Re: FortisBC Energy Inc. (FEI)

**Application for a Certificate of Public Convenience and Necessity for the
Okanagan Capacity Upgrade Project (Application)**

**Response to the Residential Consumer Intervener Association (RCIA)
Information Request (IR) No. 2**

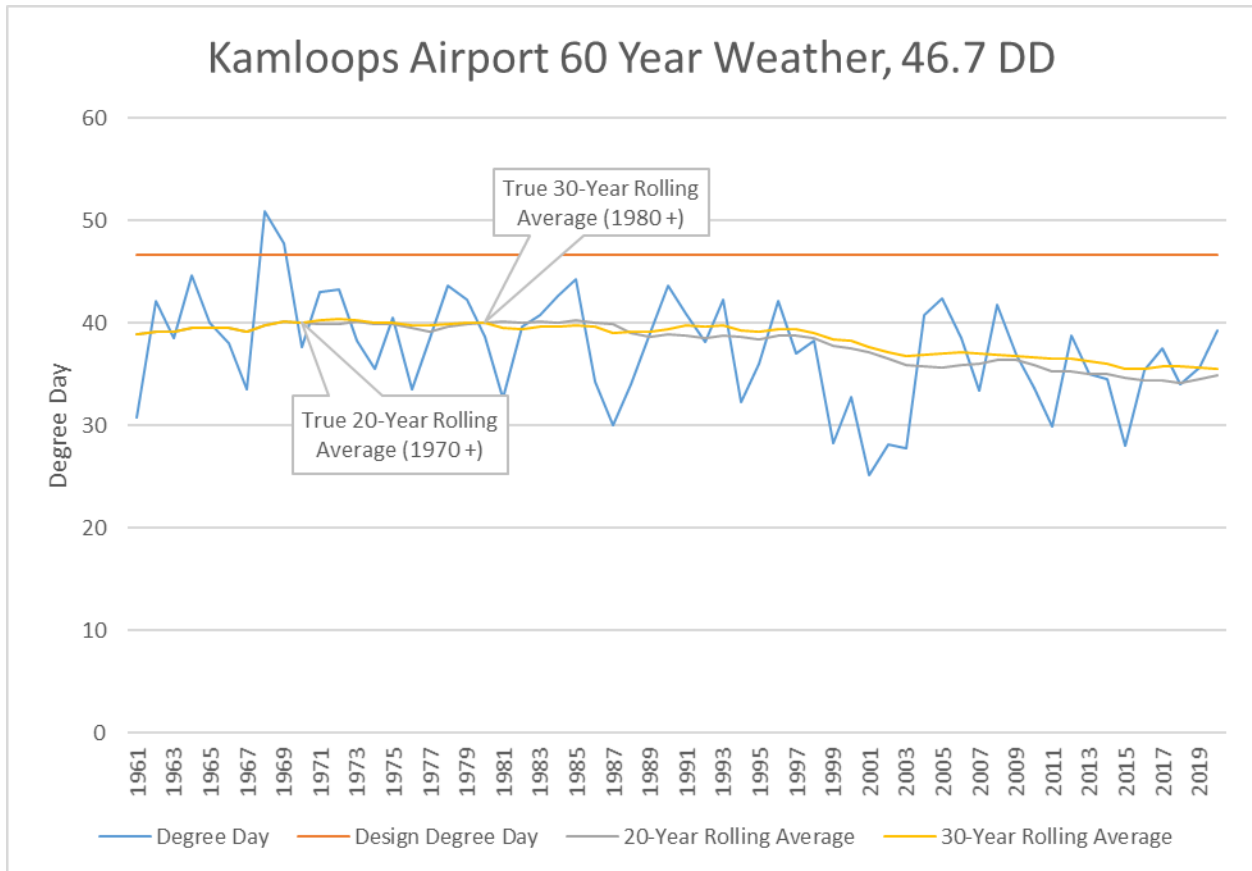
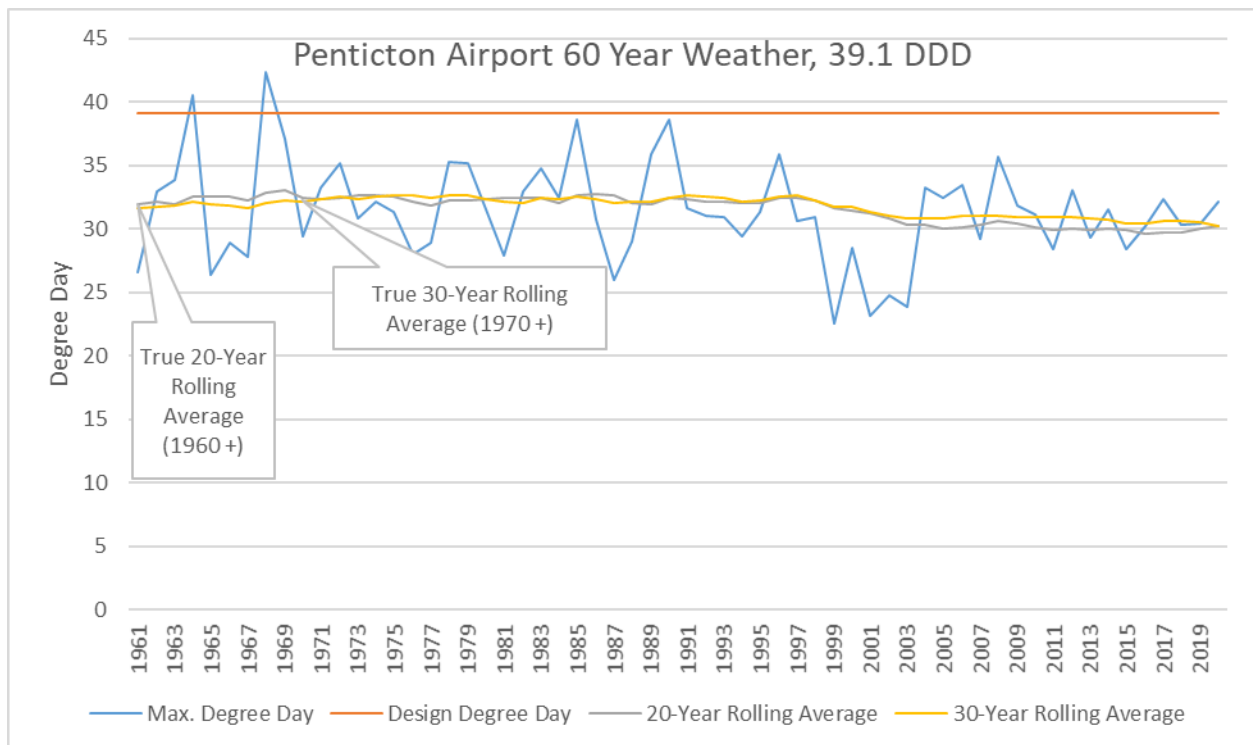
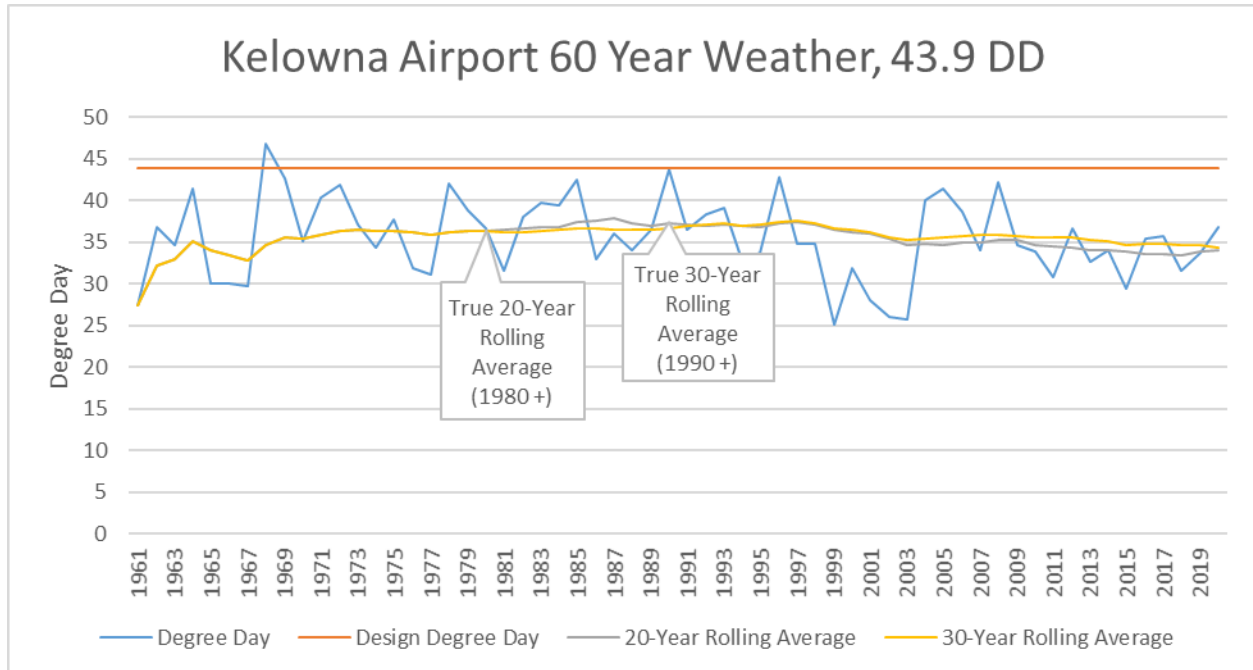
2 30.1 Please re-file the degree day graphs showing only the highest degree day each
3 year. Overlay 20- and 30-year moving averages on the resulting data sets.
4

30.1.1. Provide FEI's comments on any observed trends in the above graph.

6 FEI provides graphs below to show the requested information. By definition, calculating a rolling
7 average requires sufficient historical data. For example, a 20-year rolling average only becomes
8 a true 20-year average when 20 years of data are available; similarly 30-year rolling averages
9 only become valid when 30 years of data are available. This varies for each weather zone
10 based on the amount of reliable historical data available. The point at which each 20- and 30-
11 year rolling average becomes a true 20- or 30-year average is indicated on each graph.

2 In all weather zones, the rolling averages indicate a slight warming trend over the 60 year
3 period. Each weather zone experienced a five year period between 1999 and 2003 where a lack
4 of extreme temperature occurrences persisted. That five year period has a more noticeable
5 warming effect on the rolling averages than any other period. In the most recent 15 year history,
6 from 2004 onward, warming of the rolling averages appears to slow, but is influenced by that
7 relatively warm period. In the period just prior to 1999, between 1980 and 1998, the rolling
8 averages both warmed about 1°C in the Thompson Region (Kamloops), cooled about 0.9°C in
9 the North and Central Okanagan (Kelowna) and remained reasonably constant warming very
10 slightly by 0.2°C in the South Okanagan (Penticton).

ITS Forecasted Peak Demand Comparison

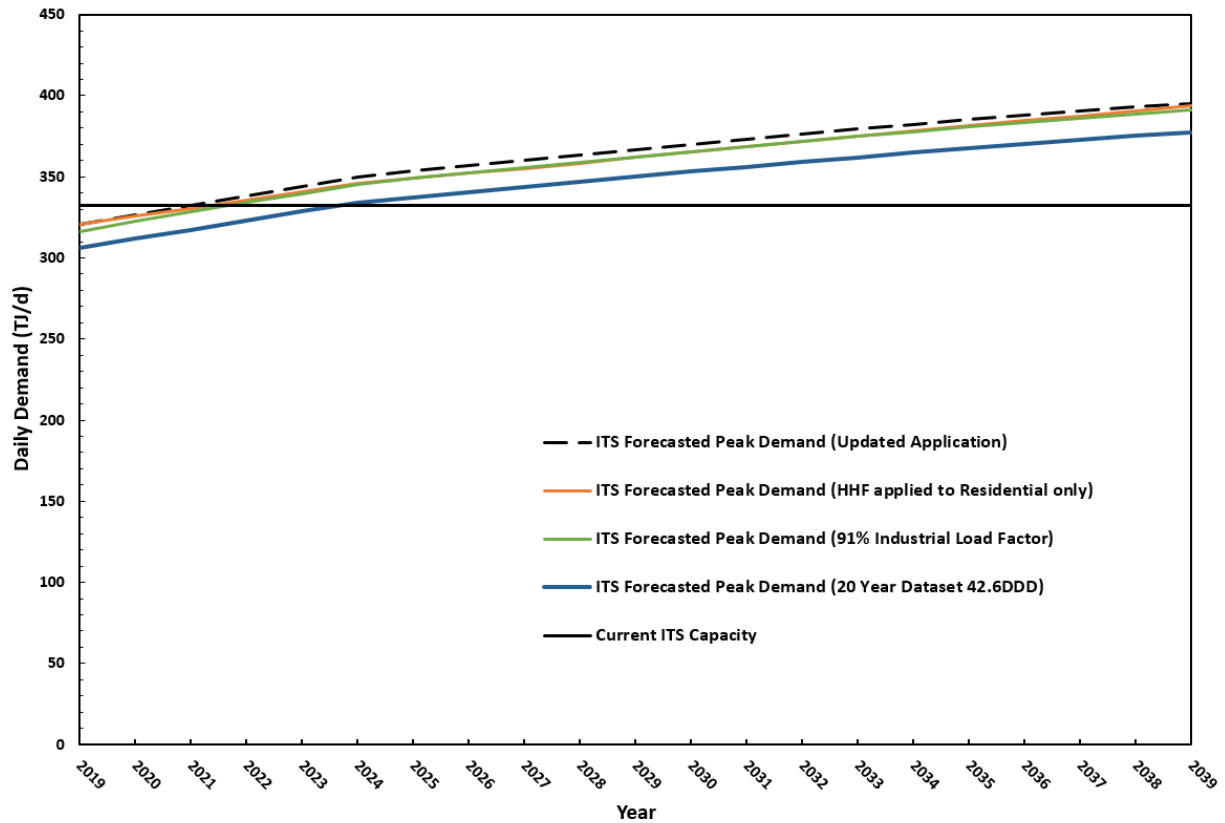
31.1 Recalculate the forecasted ITS peak demand with the following adjustments and graphically show the peak demand forecast along with ITS capacity (similar to Figure 4-1). Show the effect of each adjustment separately.

1. Do not true-up the residential customer forecast with the CBOC forecast data and instead use the LHA forecast of housing starts.
2. Apply a load factor, such as an average of the past three years, to the industrial peak hourly demand when calculating the peak daily demand.
3. Use a more recent data set of 30 years for the design degree day calculations.

The figure below presents the peak demand forecasts adjusted as requested. In BCUC IR2 43.3 FEI was asked to calculate the peak demand using a dataset of 40 and 20 years. In this response, FEI has presented the lowest forecast from the 20 year dataset (the lowest forecast) rather than generate another forecast using a 30 year dataset as it would be very similar to the forecasts using the 20 and 40 year datasets. FEI believes its established forecast method is an appropriate and prudent approach to ensuring reliable service to FEI's customers under peak demand conditions.

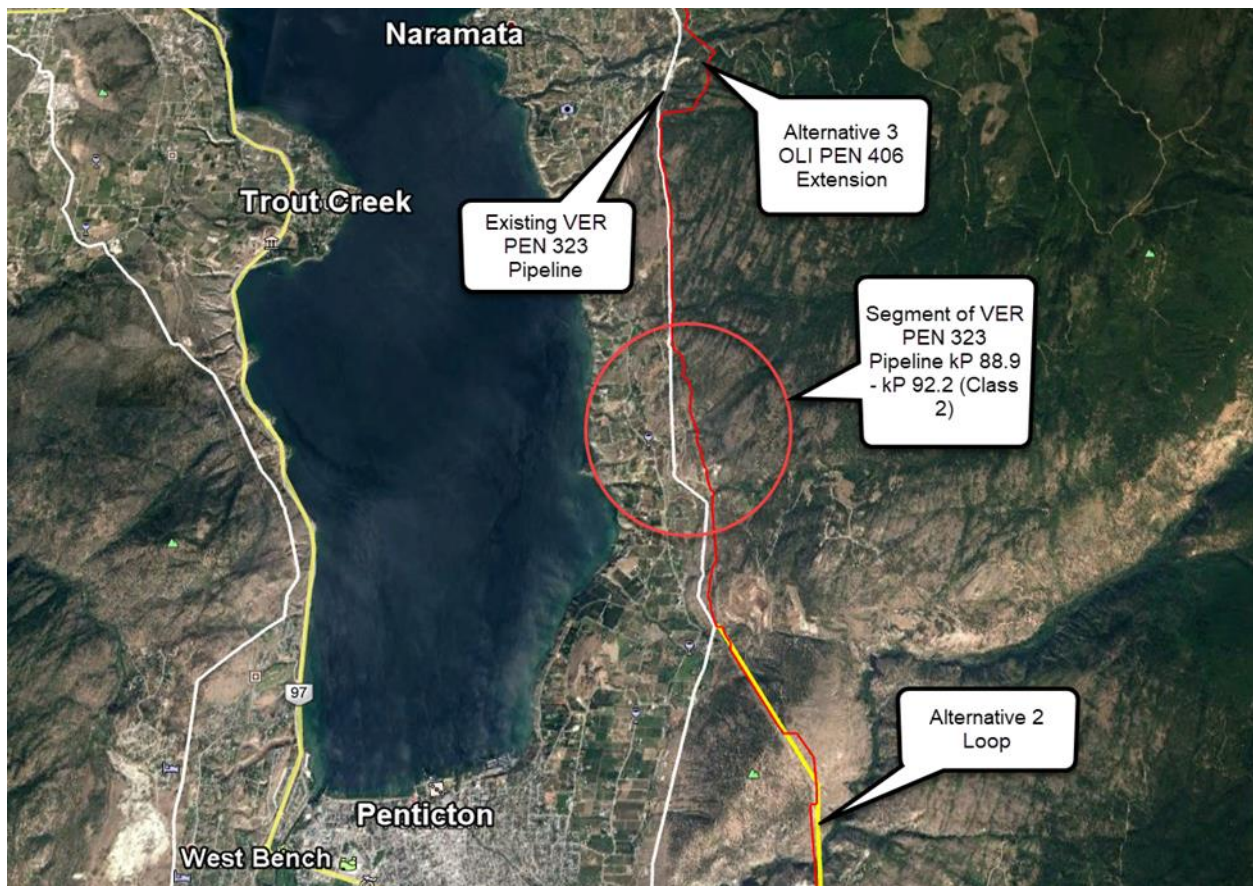
33.3 Confirm whether a class location change from class 2 to class 3 in the area of kilometer post 88.9 to kp 92.2 would cause FEI to derate the MOP of the VER PEN 323 line.

No derating would be required. In the case that this segment changes to a Class 3 location in the future, the current MOP would be sufficient. An image of the pipe segment in question is provided below.
